SUBJECT: Board of Zoning Adjustment Case No. 16792 + 16793
Alan & Anexora Skvirsky – 1606 19th St., NW
Anexora Skvirsky – 1604 19th St., NW
Square 111 Lots 52 & 53

MEMORANDUM

SUBJECT: BZA Case No. 16792 & 16793
Alan & Anexora Skvirsky – 1606 19th St., NW
Anexora Skvirsky – 1604 19th St., NW
Square 111 Lots 52 & 53

HISTORIC PRESERVATION REVIEW BOARD
STAFF REPORT AND RECOMMENDATION

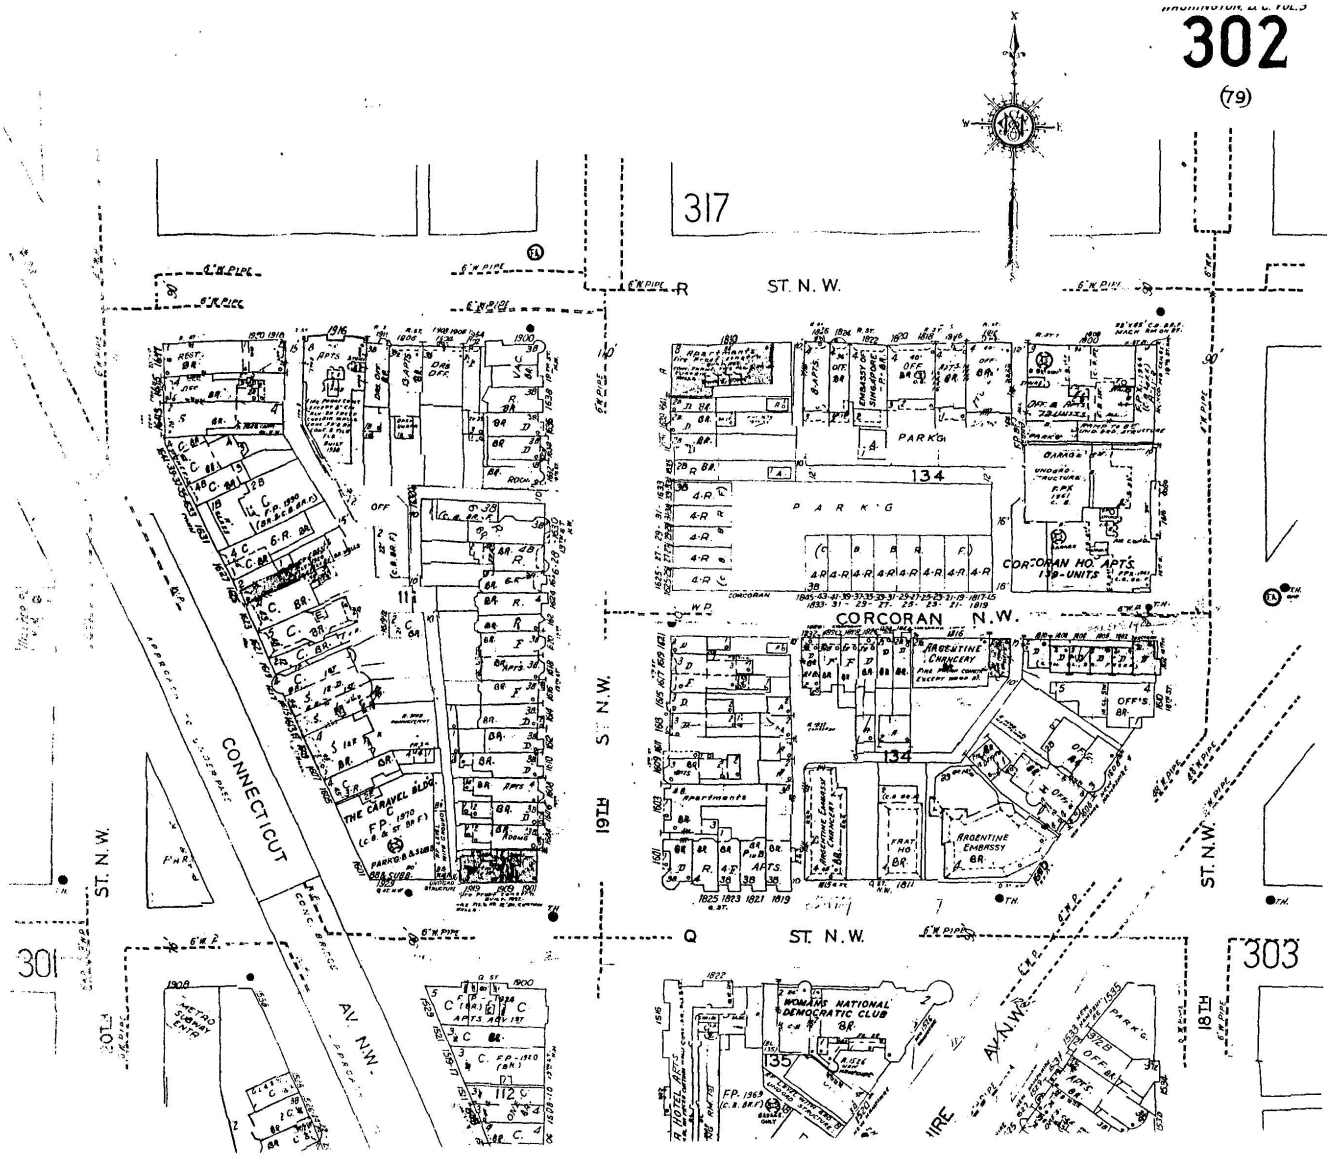
Given the particular conditions of this site and the clearly commercial nature of this alley, it seems reasonable that some type of addition on the rear of these houses would be acceptable and not inconsistent with the character of the historic district. Immediately across the alley, at 1609-11 Connecticut Avenue, the Board recently approved a large two-story addition on the rear of former houses now in commercial use that also fill their entire buildable lot. However, as proposed, the addition is simply too large; it appears as if the building is being swallowed. The staff would recommend the height of the enclosure be limited to the top of the second floor. This would allow the lower floors

closest to the alley to have some protection while still retaining some understanding of the rear massing and roof lines of the houses. The applicant may want to also look at reducing the scale of the grid (currently measuring about 10' x 8') to a slightly smaller, less commercial scale.

The staff recommends that the Review Board direct the applicant to continue studying a lower, 2-1/2 story rear enclosure as suggested above, and return to the Board once the zoning and building code issues are more fully resolved.

Board approved staff report. Did not grant conceptual approval, but encouraged applicant to pursue something along the lines of what staff was suggesting and return once outstanding issues are more fully resolved. Third floor enclosure should be a separate enclosure, rather than connected to main greenhouse below, so that awkward roof form can be eliminated.
